Proposed Final Amendment

1996 Remsen-Lake Placid Travel Corridor Unit Management Plan

Final Supplemental Environmental Impact Statement

Review of Rails-With-Trail Design Proposal by Trail with Rail Action Committee (TRAC)

TRAIL SECTION: Tupper Lake, International Paper Conservation Easement

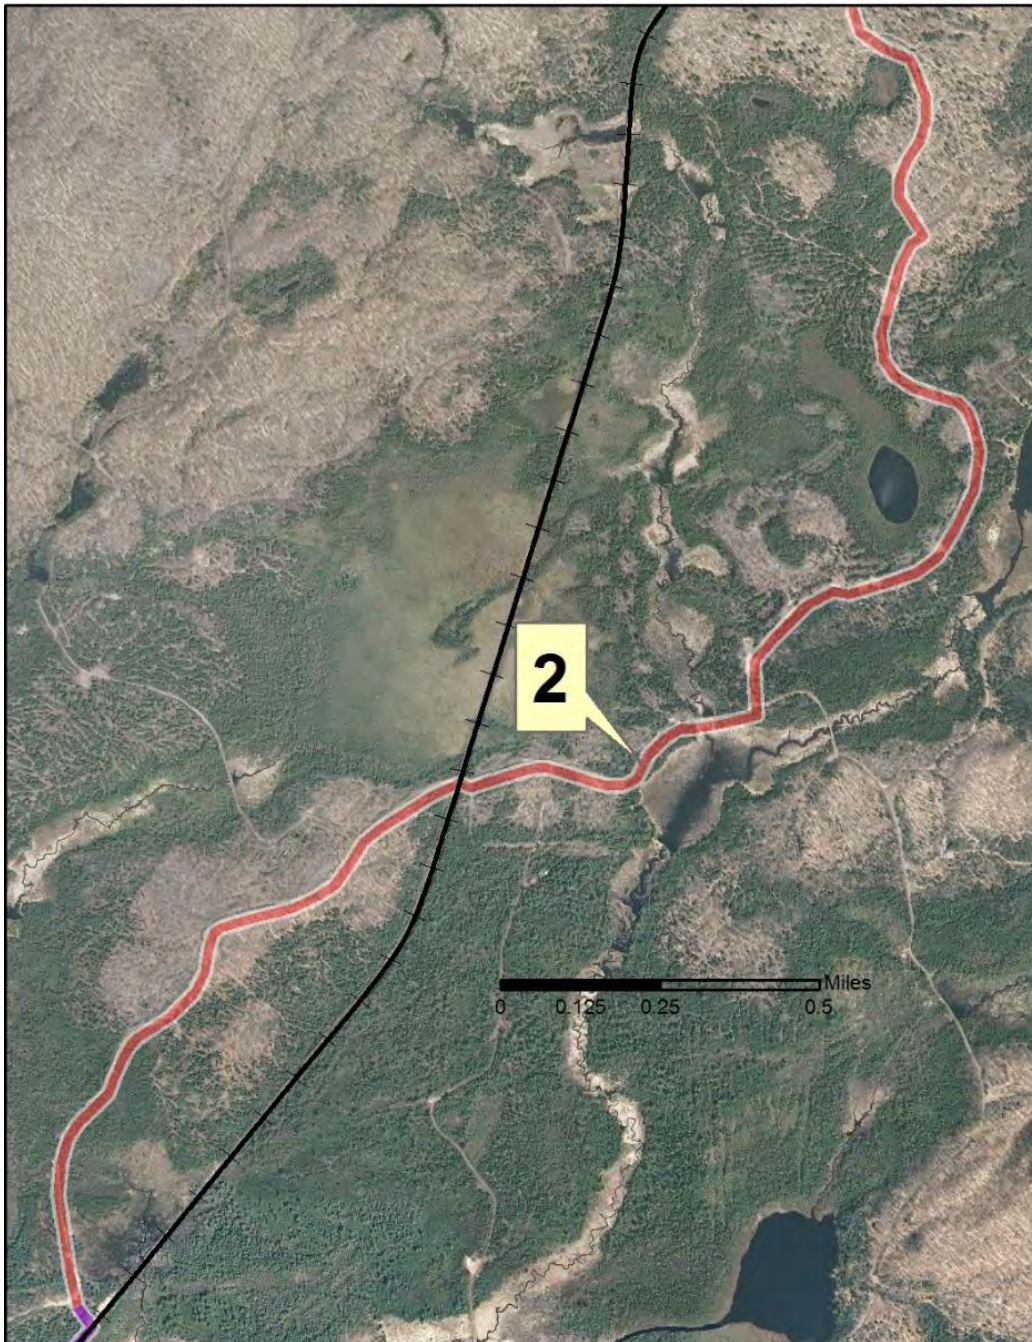
TRAC proposes to route the public “Along the Corridor” (**Map Label #1**), where an estimated 1 mile of potential wetlands would need to be filled in to complete a parallel trail. This segment is located between Tupper Lake and the start of TRAC’s alternative route off the Corridor on the conservation easement.

TRAC's suggested route off the Corridor in this segment (**Map Label #2**), could potentially become a public trail. The route shown uses logging/skid roads and traverses some very wet areas. There is potential to re-route TRAC's route through drier areas on this easement. It is important to note that the roads/trails on this property are shared with leased hunting camps and logging operations, so safety and user experiences relating to this must be taken into consideration. Snowmobiling and biking could both be theoretically possible off the Corridor in this easement.

TRAIL SECTION: International Paper Conservation Easement to Rollins Pond

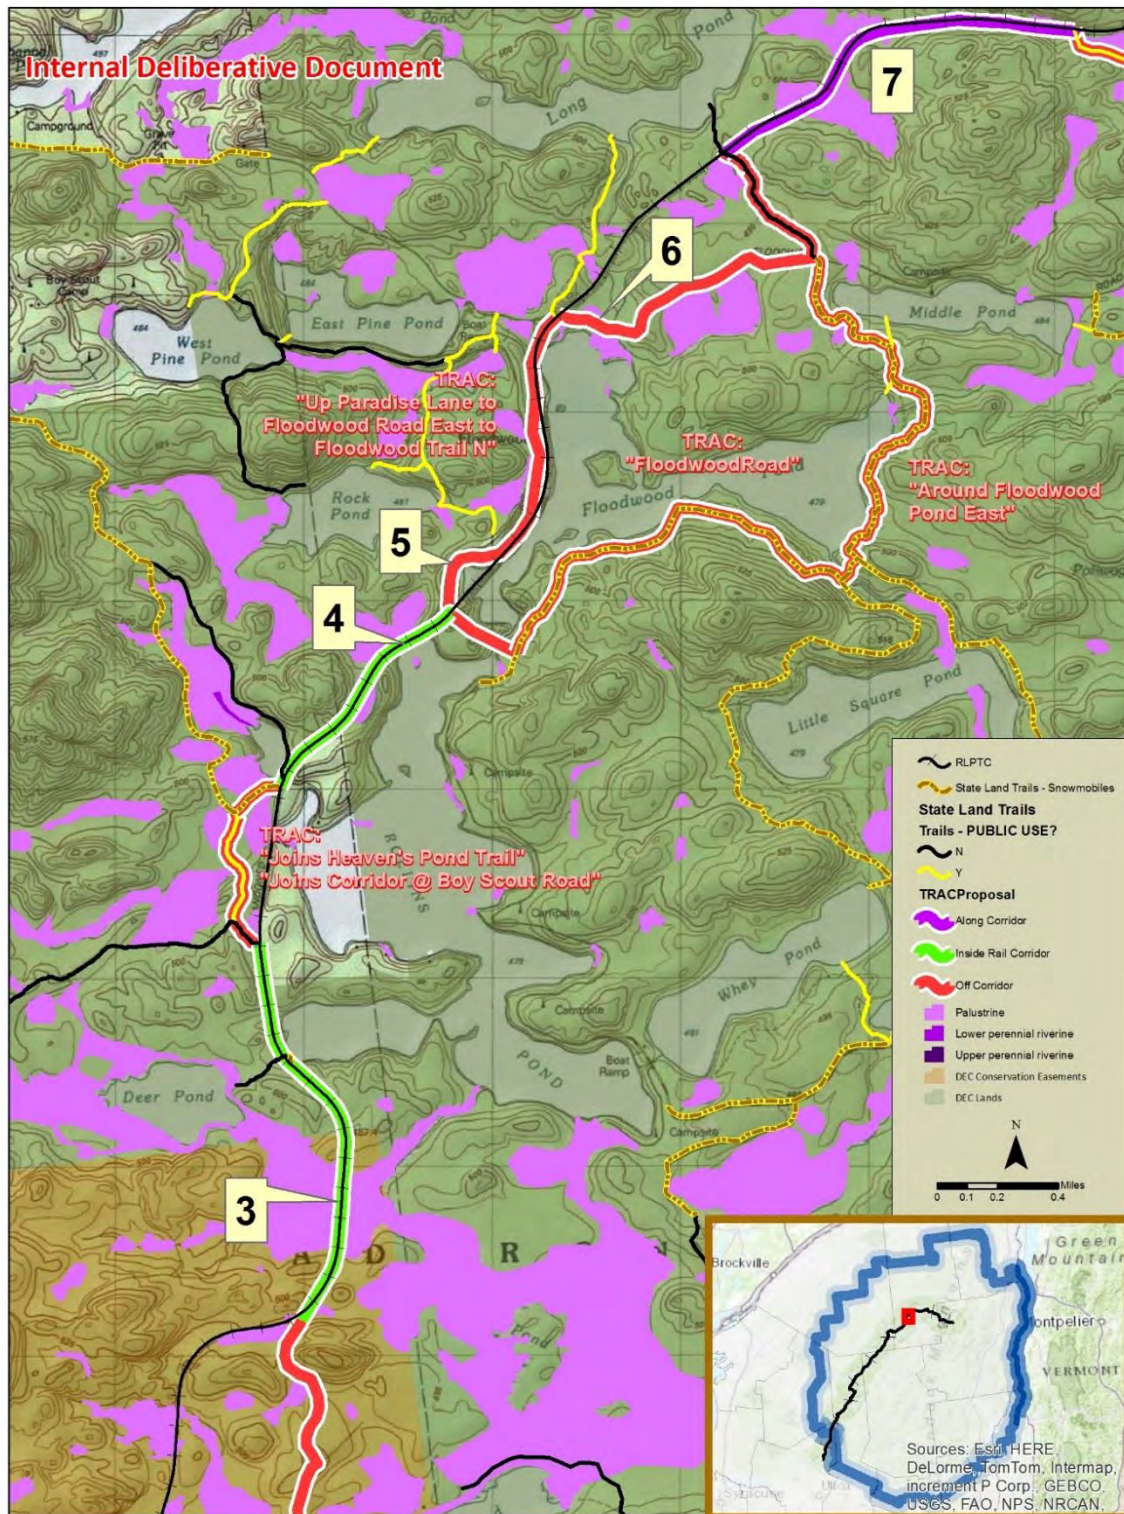
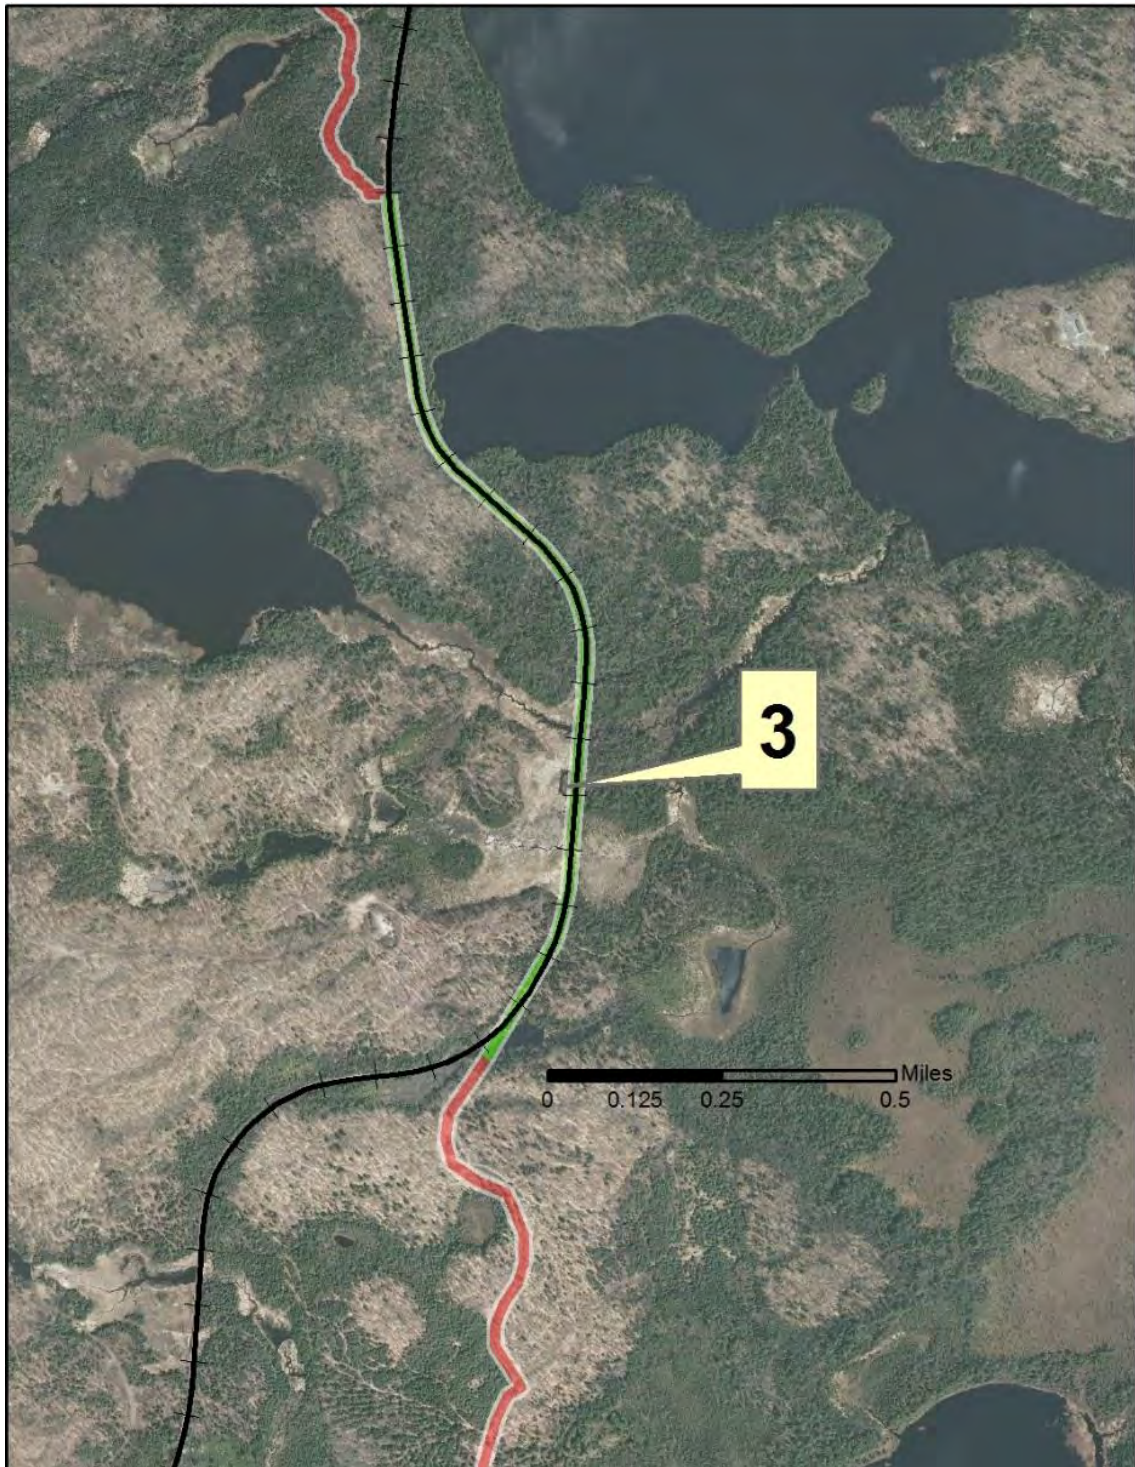
The segment of trail “Inside the Rail Corridor” TRAC proposes in the vicinity of **Map Point #3** passes through significant wetlands that would need to be filled in, for an estimated 1/3 of a mile.

Map Point #4, a stretch that TRAC proposes to go “Inside the Rail Corridor”, there is a significant causeway at a rail bridge with Rollins Pond on one side and a large wetland on the other, making it too narrow for a rail and parallel trail.

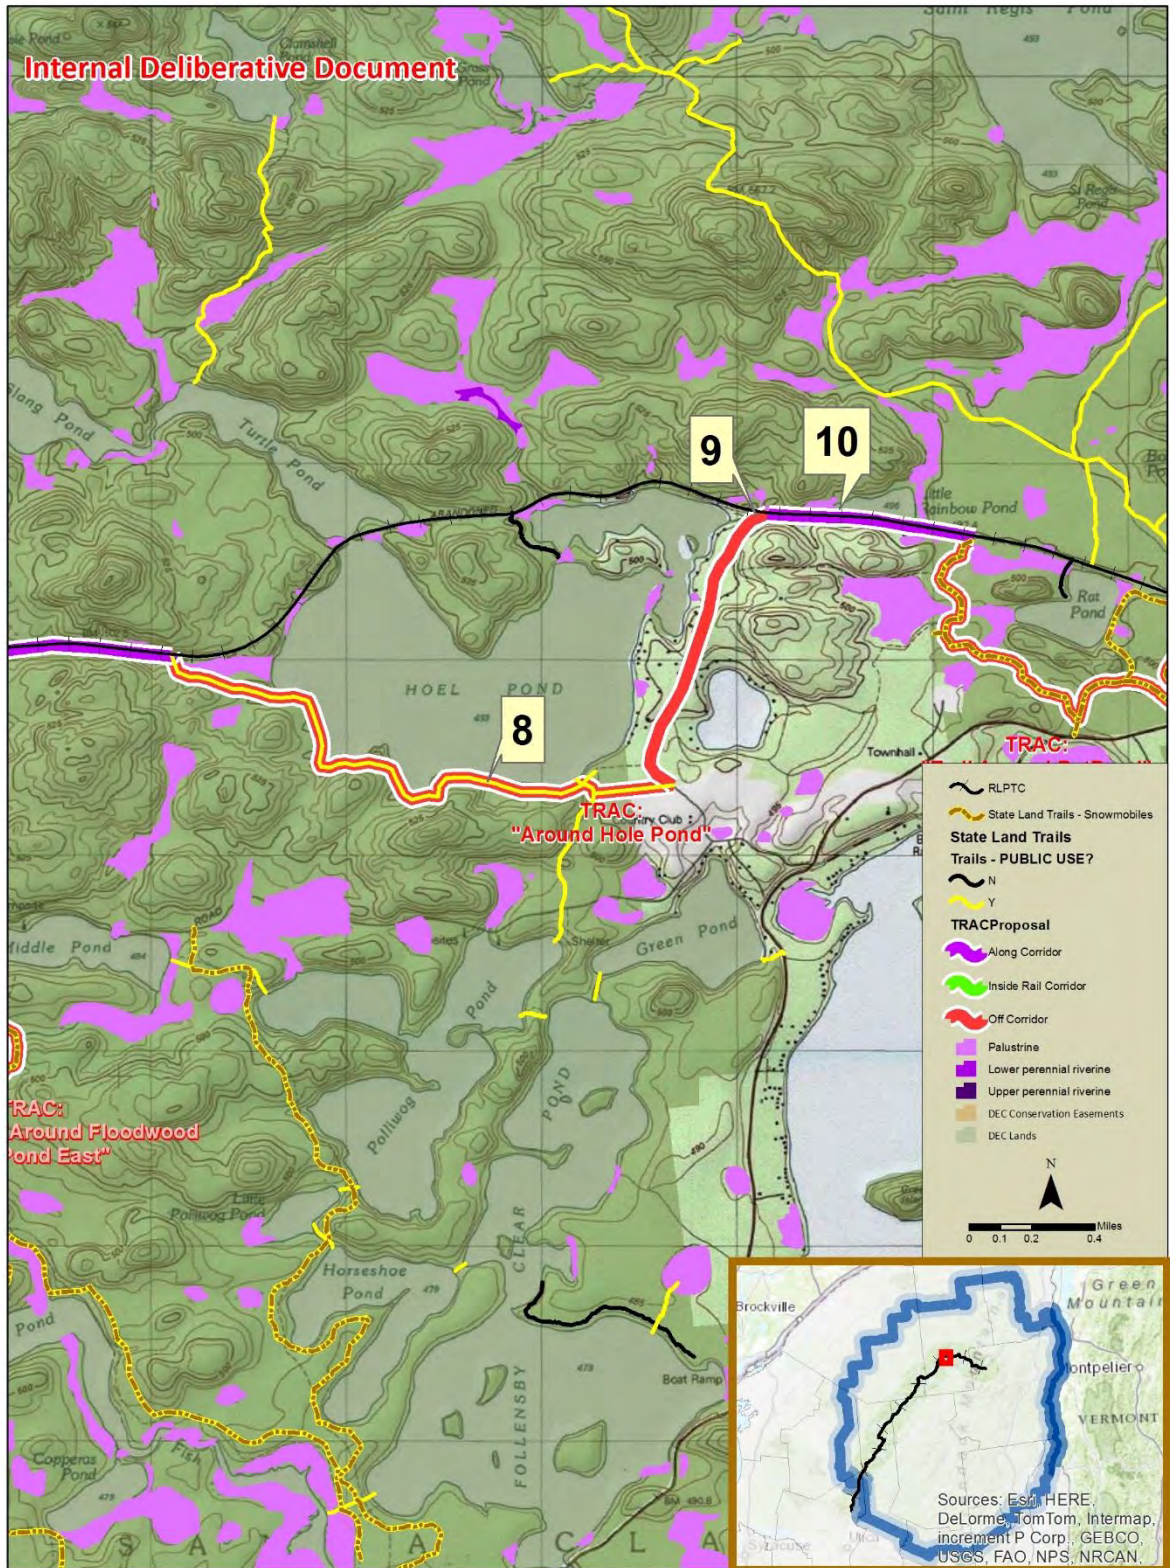
Map Point #5 shows the vicinity of Paradise Lane. This part of TRAC's alternative is probably not feasible because that road is mostly privately-owned, and therefore would require private landowner permissions.

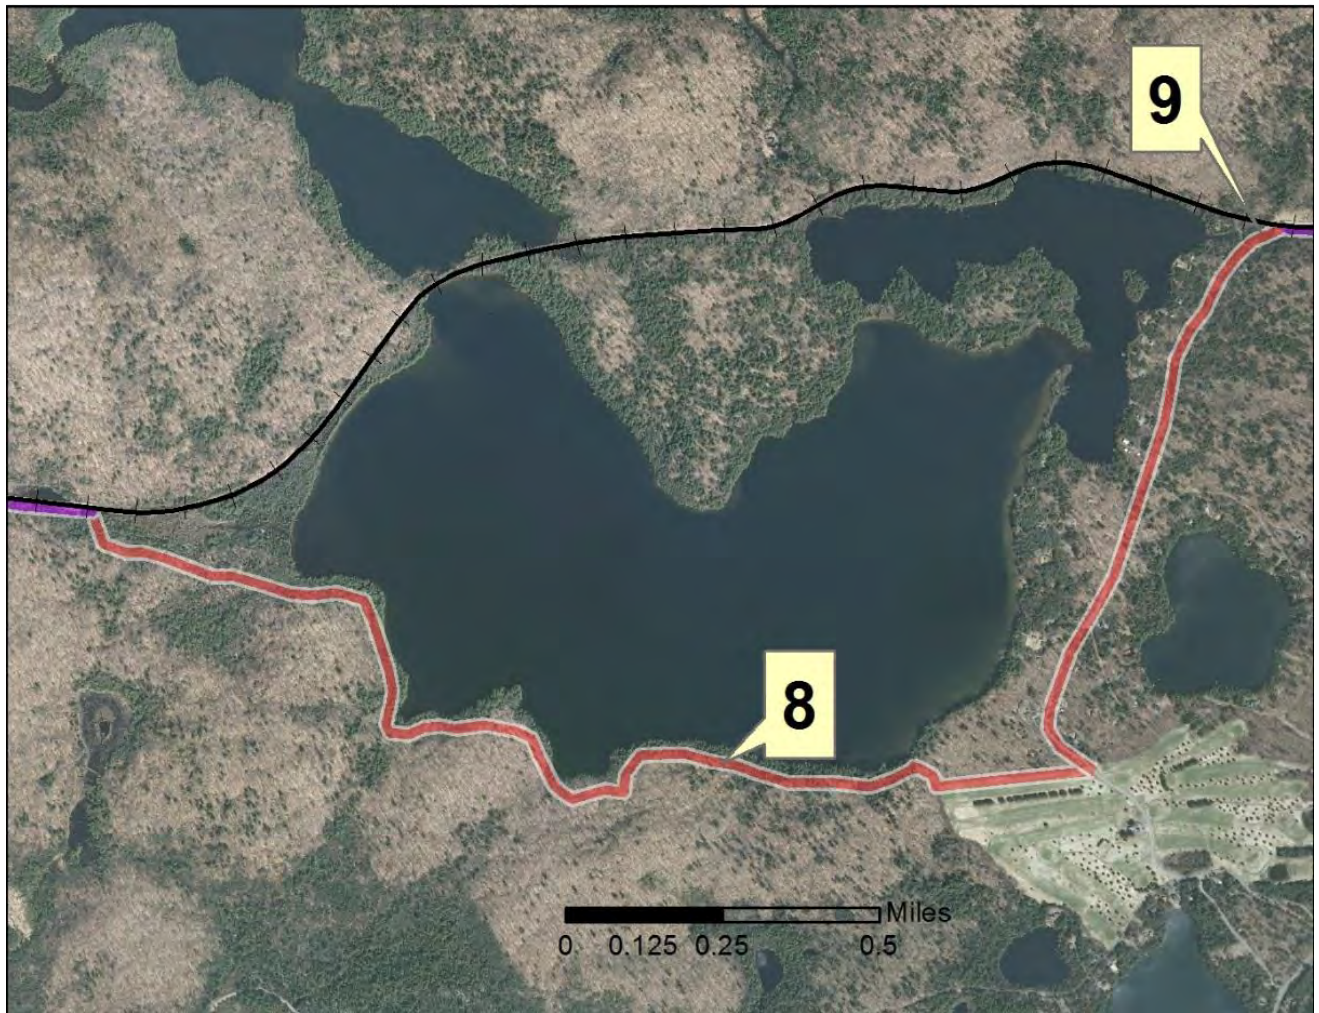
Map Point #6 notes where a significant bridge would need to be built at the Rollins Pond outlet, in order for this alternative to be feasible. This bridge is highly desirable from a DEC perspective for trail connections with the Rollins Pond/Fish Creek Campgrounds. That would make TRAC's Floodwood Road route possible. Some sections of TRAC's Floodwood Road loop would need to be improved and opened to public use.

Map Point #7 shows where TRAC proposes a segment approximately 0.5 miles “Along Corridor”, which would result in adverse impact or loss of regulated wetlands.

TRAIL SECTION: Hoel Pond

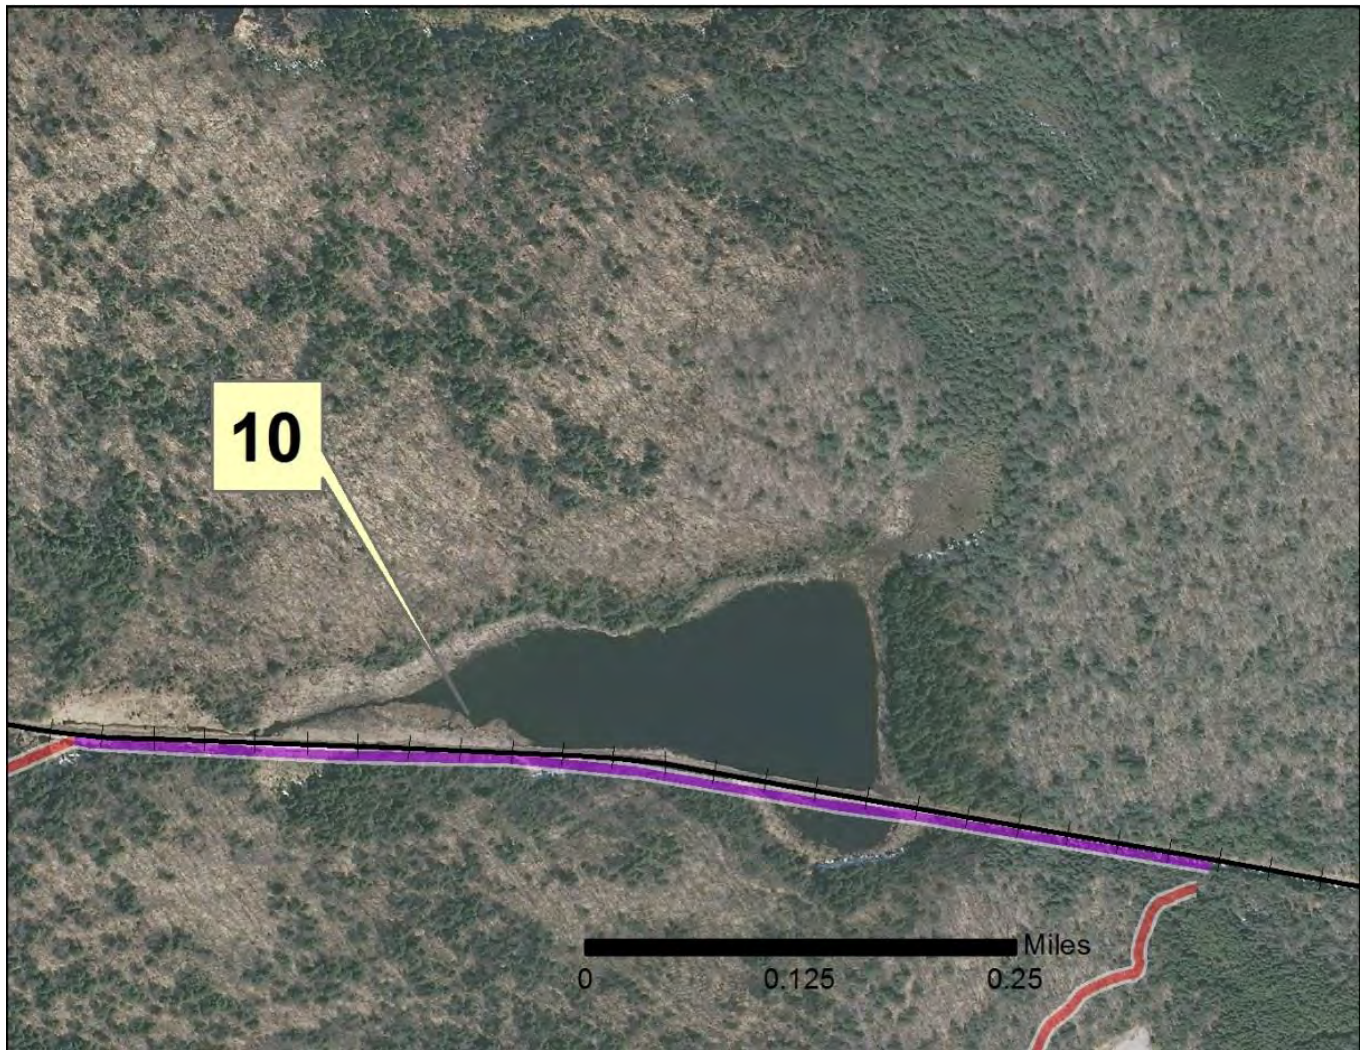
TRAC's suggested route in this map, at **Map Point #8**, goes around Hoel Pond. It starts as a herd path on the southeast side of the pond, and diminishes going west, where there are currently some primitive campsites. It is feasible that this trail system can be upgraded. This proposed segment, however, bypasses potential future access locations for people with disabilities. The Corridor offers easier water-access potential than the Hoel Pond loop.

At **Map Point #9**, shows the town road being utilized as an alternative route in the TRAC proposal, heading north from the country club, has private property at the end. Any connection to the Corridor from this road would need to be negotiated with the private landowner.

At **Map Point #10**, TRAC's "Along Corridor" segment goes through wetlands and over an open water causeway, making this proposed segment infeasible.
